**COUNCIL SUBMISSION – MIXED USE DEVELOPMENT, COLUMBIA PRECINCT, 2-20
PARRAMATTA ROAD & 11-13 COLUMBIA LANE, HOMEBUSH, (MP 10_0143)**

STRATHFIELD COUNCIL SUBMISSION
Columbia Precinct, 2-20 Parramatta Rd & 11 – 17 Columbia Lane MP 10
0143 Mixed Use Development Concept Plan Application

Figure 3 Early version of draft LEP, FSR, Height and indicative DCP footprints as forwarded with DGR comments to Department in October 2010.

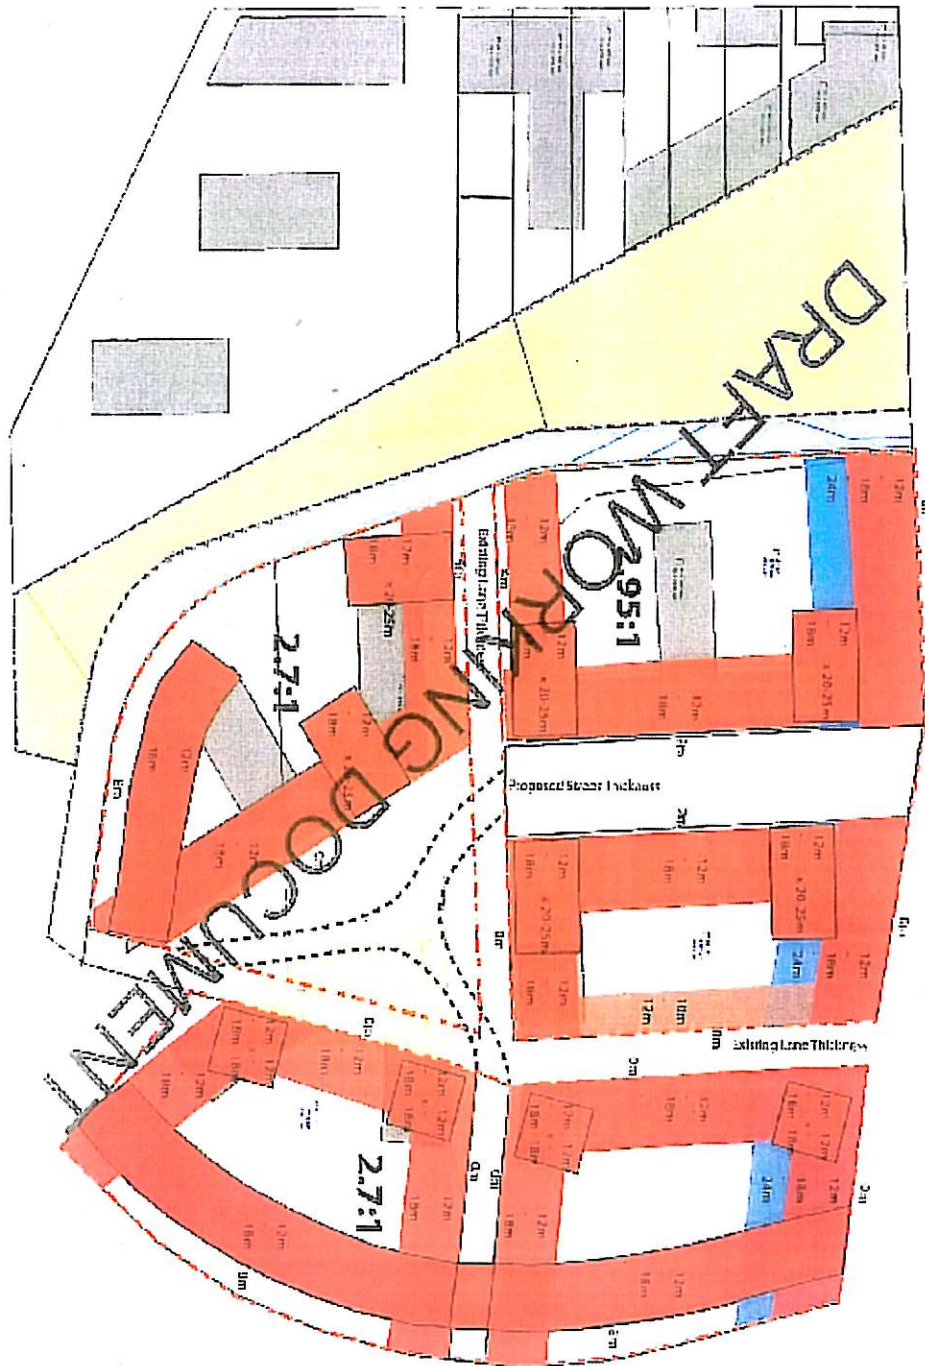
The built form wall along Parramatta Road can be clearly seen in the built form plan Council provided to the Department at DGR stage for this Part 3A application (refer **Figure 3**) and as indicated in Councils current DCP 20. The six level height is designed to act as a noise wall as much as being a street defining element. The plan also shows, the curving buildings around the east and southern sides also act as noise barriers to reduce the railway noise. Within the site, the buildings are setback 8m from the boundary to allow quality ground level deep soil planting to separate the buildings from

Given the approach of this Part 3A Concept Plan, with increasing height, from low (2 storey) at Parramatta Road to high (21 storey) near the railway, it is considered that there will need to be greater noise protection for the majority of apartments, as there is no significant noise barrier, and noise can echo between the buildings. Noise from Parramatta Road and the M4 Motorway will also not be blocked by this approach in the Concept Plan.
